City of Phoenix
PLANNING AND DEVELOPMENT DEPARTMENT

Staff Report: Z-SP-2-24-3
January 24, 2025

Proposal: Special Permit to allow sales, parts and service dealership for new and used UTV's, ATV's, motorcycles, personal watercrafts, etc., and all underlying C-2 uses

Location: Approximately 125 feet south of the southwest corner of Cave Creek Road and Hartford Avenue

Conceptual Landscape Plan

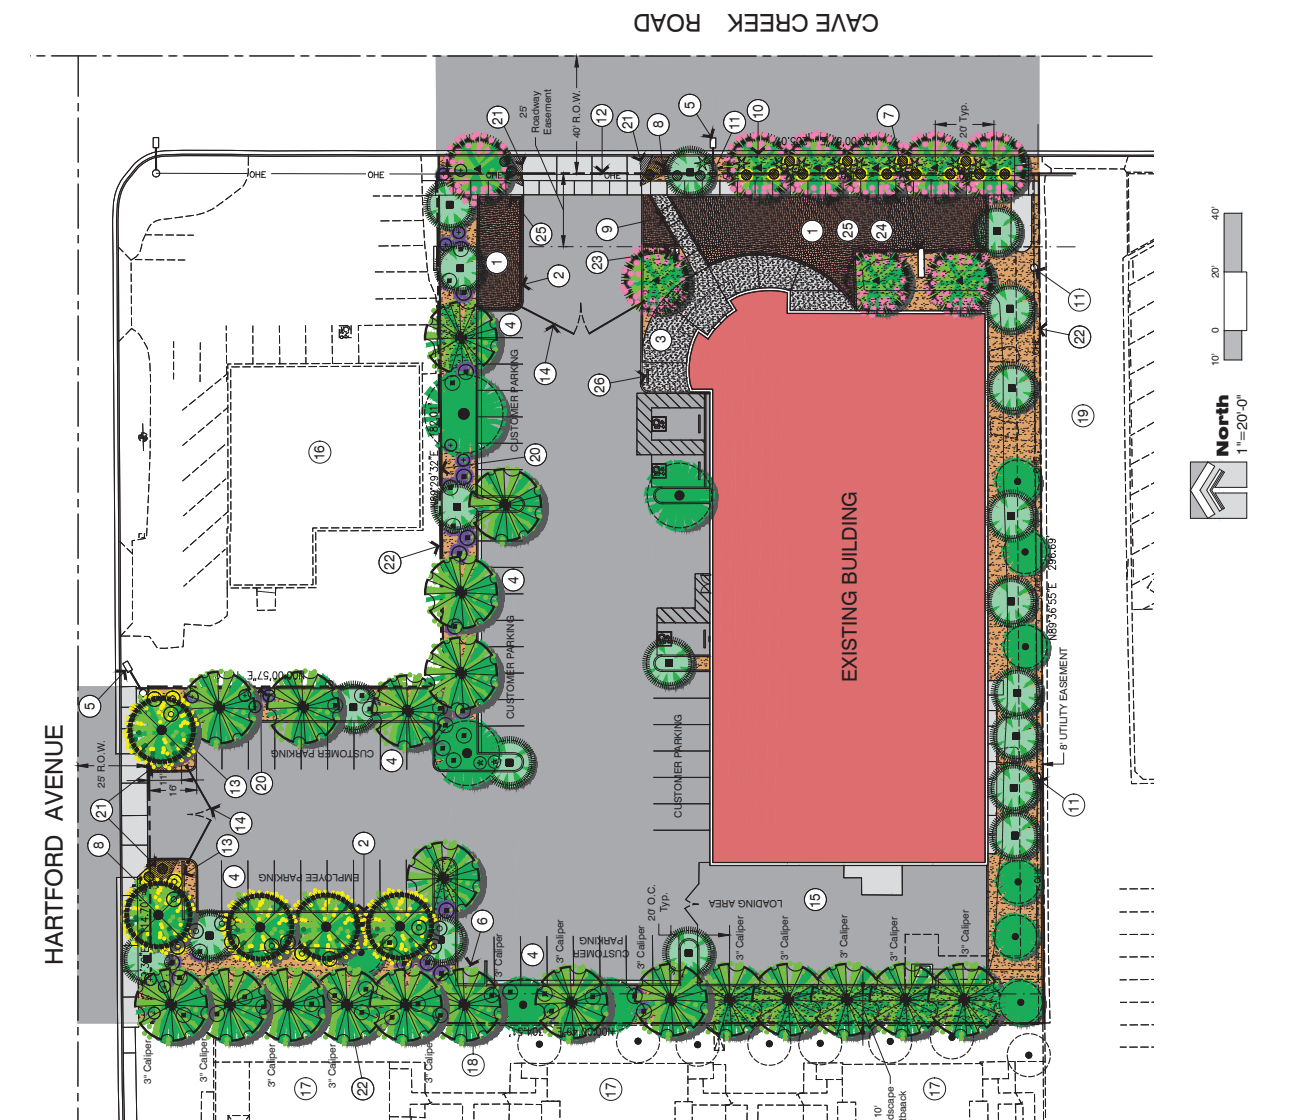
3. The required perimeter landscape areas, and the perimeter landscape areas as depicted on the conceptual landscape plan date stamped January 9, 2025, shall be replenished with minimum 2-inch caliper, large canopy, shade trees, planted 20 feet on center or in equivalent groupings, and a minimum of five 5-gallon shrubs per tree, as approved by the Planning and Development Department.
